# UNITED STATES PATENT AND TRADEMARK OFFICE

10/552,838

Yun-Seok Choi

<b>Office Action Summary</b>	Application No. 10/552,838	Applicant(s) CHOI, YUN-SEOK	
	Examiner Sundhara M. Ganesan	Art Unit 3764

Fig. 1 of US Pat. 6,394,936 (annotated by examiner)

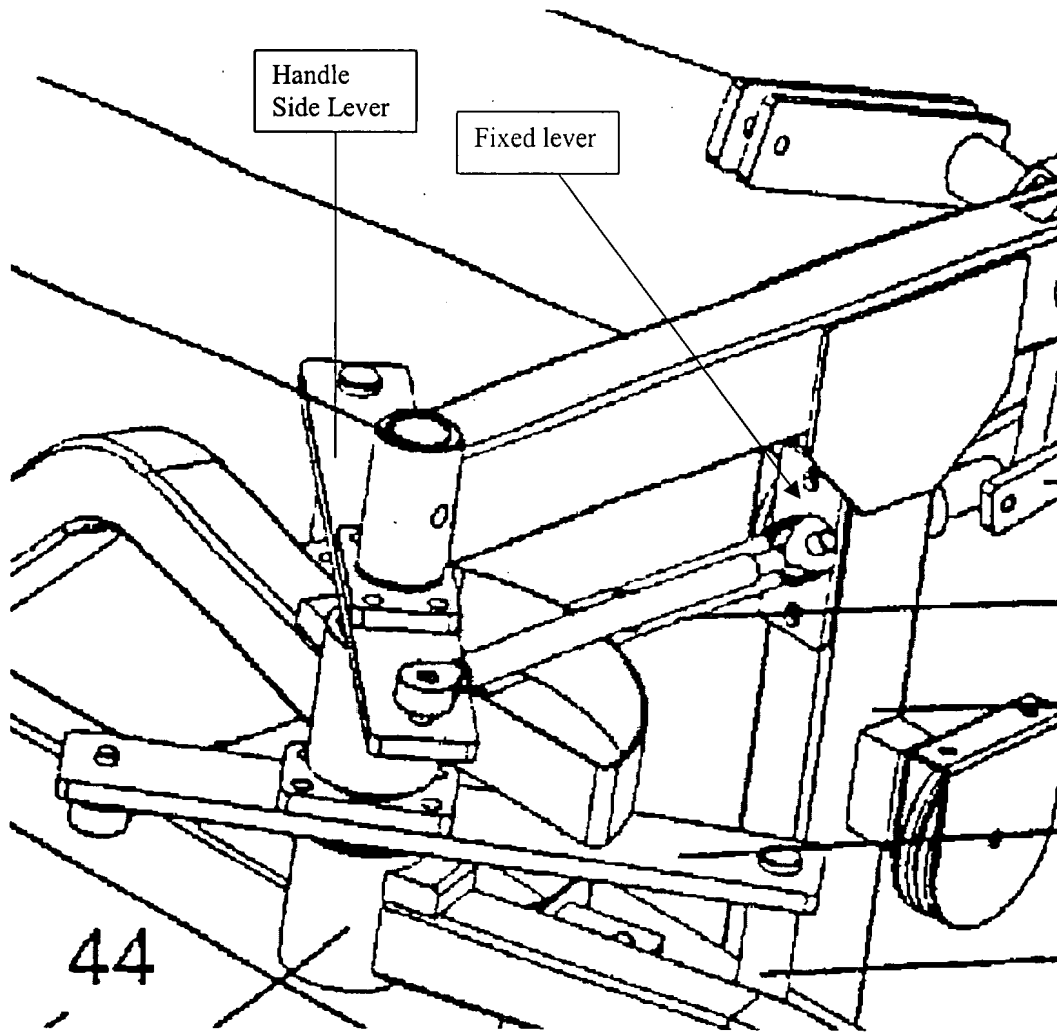
6. Claim 1 is rejected under 35 U.S.C. 103(a) as being unpatentable over Voris (US Pat. 6,394,936). Voris describes substantially the same invention as claimed, including: an I shaped base frame (10), a tower (20) mounted to the top surface of the I-shaped base frame, a seat (87) mounted on the base frame, handle linkages (31) each inclinedly mounted at right and left sides of the base frame via bearings (26) in such a manner as to form an angle  $\alpha$  in front of the seat (Fig. 1) to perform angular motion back and forth; a bearing box (27) mounted on the front end of the handle linkage, first and second handle frames (24, on the left and right side of the machine) rotatably mounted on a handle shaft (26), the first handle frame being connected to the handle shaft, the second handle frame being connected to the handle shaft at an angle (Fig. 2); a handle side lever (28) fixed between the first handle frame and the bearingbox in such a manner as to form a predetermined angle with respect to the first handle frame (Fig. 1); and an auxiliary linkage (30) connected to an upper end to the handle side lever via a

ball joint (see Fig. 1) and mounted at lower end on a fixed lever (see Fig. Below) fixed to the base frame via a ball joint.

Voris does not show the fixed lever as being fixed to the lower end of the front side of the base frame.

At the time the invention was made, it would have been obvious to one having ordinary skill in the art to change the position of the arm assembly of Voris such that it is located on the lower front end of an exercise machine. The function and components

are the same; only the placement on the device is changed, which would allow for exercising different muscle groups. According to MPEP §2144.04, rearrangement of parts is not a patentable advance. The operation of the parts described by Voris and the operation of the invention described in claim 1 is identical except for the placement of the arm assembly. One having ordinary skill in the art could make this rearrangement with the motivation to exercise other muscle groups on the human body. See *In re Japikse*, 181 F.2d 1019, 86 USPQ 70 (CCPA 1950) and MPEP §2144.04 (VI).

Regarding claim 2, Voris shows the handle linkages as axially mounted to the base frame at angles for trapezoidally angular motion of the right and left directions (see Fig. 7, the trapezoidal motion is from the path of the two hands and the points B and B'); the auxiliary linkage (30) is connected to the fixed lever (see Fig. 1 annotated above) via the ball joint in front of or behind the lower portion of the handle linkage on the base frame and is separated from the handle linkage at a predetermined distance; the ball joints located on the upper and lower portions of the auxiliary linkage (30) are arranged in a perpendicular direction to each other (Fig. 1); the bearing box (27) is fixedly mounted on the lower end of the handle linkage so that the handle shaft (26) is axially mounted to the bearing box (27) at an angle; the first handle frame is fixed to the handle shaft (Fig. 2) axially mounted to the bearing box (27) and the second handle frame is connected to the handle shaft at an angle in such a manner as to adjust an angle of a handle or to mount two or more handles (Fig. 2); the handle side lever (Fig. 1 annotated as above) is fixed between the bearing box and the first handle frame mounted on the handle shaft (26) to form a predetermined angle with respect to the handle frame (see

Fig. 1 annotation above); the handle side lever is connected to the auxiliary linkage via the ball joint and perform an angular motion in a direction of motion in a direction similar to the direction of an angular motion of the handle shaft for a smooth angular motion of the ball joint (Fig. 1 and 7).
